UNITED STATES PATENT AND TRADEMARK OFFICE

APPLICATION NO.	FILING DATE	FIRST NAMED INVENTOR	ATTORNEY DOCKET NO.	CONFIRMATION NO.
10/040,952	01/09/2002	Jun Ohshimo	020004	5112

Office Action Summary	Application No. 10/040,952	Applicant(s) OHSHIMO, JUN	
	Examiner Mirellys Jagan	Art Unit 2859

DETAILED ACTION

Fig. 4

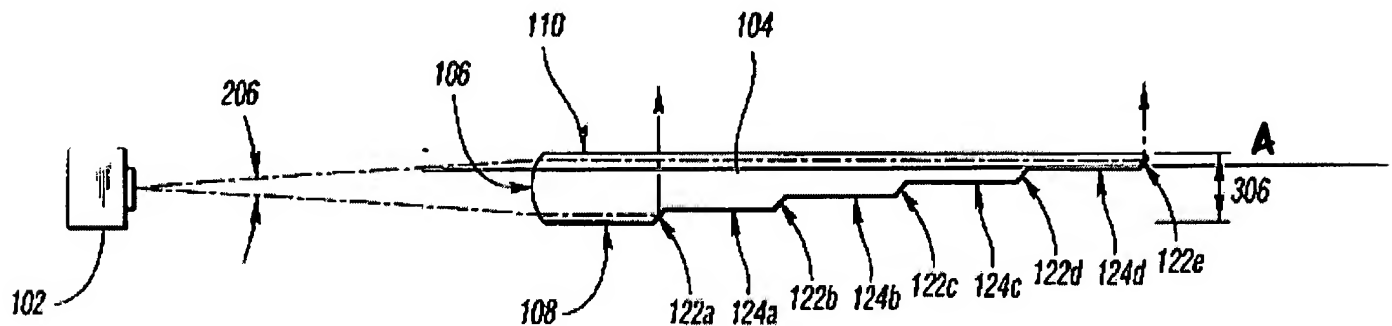
a light receiver (116) also located on the first side of the space such that it receives light emitted from the light guide and reflected by a reflective object (90) in the space;

wherein the light guide takes in the light emitted from the emitter, reflects the taken-in light at a reflection portion (108) of the light guide, and ejects the light across the space toward the reflective object; the guide is plate-shaped and comprises the reflection portion disposed on one of two parallel opposing faces (110 and A, as shown below) of the guide having larger areas than the other faces thereof; the light guide takes in the light through one of the other faces (106), reflects the taken-in light at the reflection portion (108), and ejects the reflected light from the other (110) opposing face; the reflection portion comprises a series of parallel grooves (formed at the junction of facets 122 and regions 124); and the intensity of the light emitted is 'substantially' uniform over an entire area of the face from which the light is ejected (see figures 1, 3, and 4).

FIG. 5

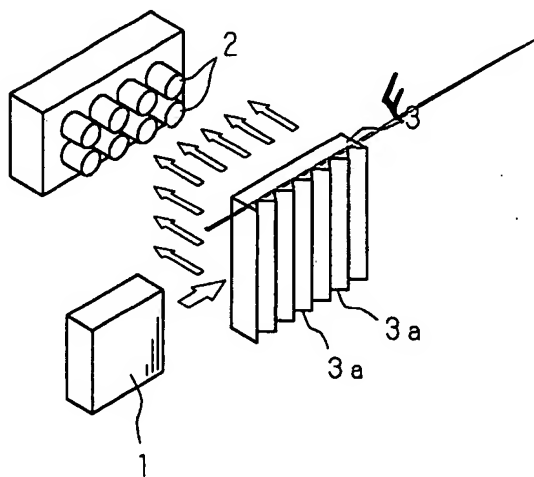
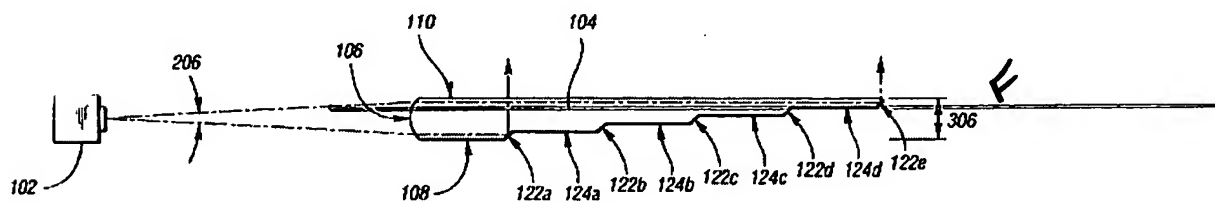
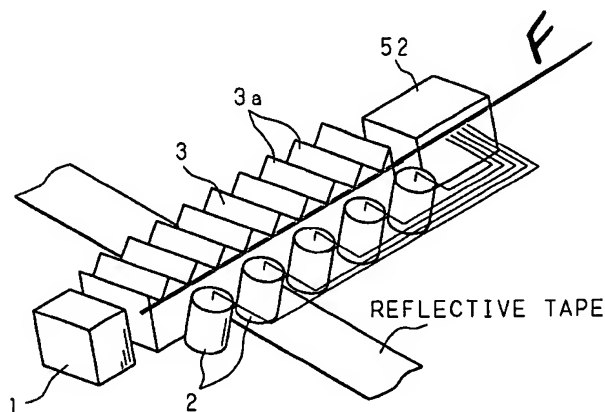
Applicant's arguments that Fohl fails to disclose a reflection portion disposed on one of two opposing faces are not persuasive. Applicant states that "top face of the light guide 3 [are] reflection portions 3a [i.e., facets] each comprising a V groove" and that "the reflection portions 3a are arranged on the *"plane"* of the light guide 3 of figure 4". However, these arguments are not persuasive since both Applicant's reflection portions and Fohl's reflection portions are on a top face/plane "F" as shown below:
